## PCI-SIG ENGINEERING CHANGE NOTICE

<b>TITLE:</b>	Power-up requirements for PCIe side bands (PERST#, etc.)
<b>DATE:</b>	September 18, 2014
<b>AFFECTED DOCUMENT:</b>	PCI Express M.2 Specification, Revision 1.0
<b>SPONSOR:</b>	Dave Landsman, SanDisk; Ramdas Kachare, LSI; David Harriman, Intel

**Figure 80. CLKREQ# Clock Control Timings**

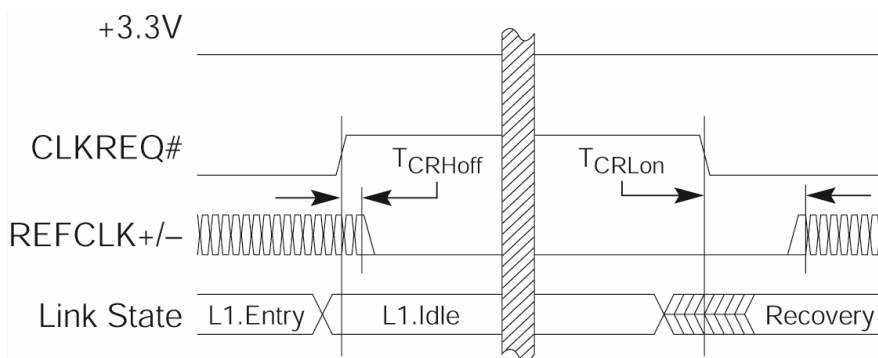
After a PCI Express device has powered up and whenever its upstream link enters the L1 link state, it shall allow its reference clock to be turned off (put into the parked clock state). To accomplish this, the device de-asserts CLKREQ# (high) and must allow that the reference clock will transition to the parked clock state within a delay ( $T_{CRHoff}$ ). Figure 80 shows the CLKREQ# clock control timing diagram.

To exit L1, the device must assert CLKREQ# (low) to re-enable the reference clock. After the device asserts CLKREQ# (low) it must allow that the reference clock will continue to be in the parked clock state for a delay ( $T_{CRLon}$ ) before transitioning to the active clock state. The time that it takes for the device to assert CLKREQ# and for the system to return the reference clock to the active clock state are serialized with respect to the remainder of L1 recovery. This time must be taken into account when the device is reporting its L1 exit latency.

All links attached to a PCI Express device must complete a transition to the L1.Idle state before the device can de-assert CLKREQ#. The device must assert CLKREQ# when it detects an electrical idle break on any receiver port. The device must assert CLKREQ# at the same time it breaks electrical idle on any of its transmitter ports in order to minimize L1 exit latency. See Table 17 for CLKREQ# clock control timing.

Figure 79. Power-Up Timing Sequence

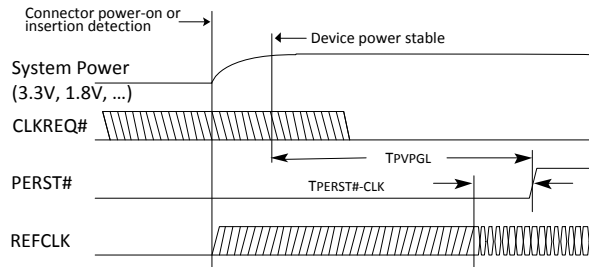
Section 3.1.3.2.1 is redefined to provide a more realistic timing model for reset. Specifically:

- a) Section is pulled out of 3.1.3, because Reset should not be placed under PCIe Side Bands, but separately, at same level.
- b) PERST# timing variable ( $T_{PVPGL}$ ) is changed to be “implementation specific”, with a recommended value, instead of the original hard minimum.
- c) CLKREQ# timing variable ( $T_{PVCRL}$ ) is removed as it is not needed specifically in relation to reset. CLKREQ# timing rules are referenced elsewhere in the spec.
- d) The reset timing diagram and reset variable value tables are modified to reflect (a) and (b), and other changes, such as that “power on” refers to power being valid on the device , not on the system.
- e) Language inserted referring to the PCI Express base spec, and BIOS/OS requirements, as they relate to  $T_{PVPGL}$ , in order to provide clearer guidance to implementers.

### 3.1.x Power-up Timing (after existing 3.1.3 and before existing 3.1.4)

Figure 79 provides an overview of the M.2 device power up sequence. Table 16 lists the power-up timing variable values.

Symbol	Parameter	Min	Max	Units
$T_{PV PGL}$	Power Valid to PERST# Input inactive	Implementation specific; recommended 50 ms		ms
$T_{PERST\#-CLK}$	REFCLK stable before PERST# inactive	100		$\mu$ S

#### 3.1.x.1 PERST# Power-up Timing

The host shall delay de-assertion of PERST# for a period of time ( $T_{PV PGL}$ ) after power is stable on the device (see Figure 79). See section 3.1.3.4 for further details on PERST#.

The PCI Express Specification (see Revision 3.0 or later, Conventional Reset) requires that a PCIe Express device must be in the LTSSM Detect state within 20 ms of PERST# being de-asserted and ready for Configuration Requests within 120 ms of PERST# being de-asserted.

The value of  $T_{PV PGL}$  is left as implementation specific, with a recommended value as a guideline. In considering the value of  $T_{PV PGL}$ :

- Device and host implementers should consult PCIe Express Reset Rules and platform BIOS and OS requirements governing device readiness timing requirements following the de-assertion of PERST#.
- Host implementers should consult device vendors for their  $T_{PV PGL}$  values, based on vendor specific device startup requirements.
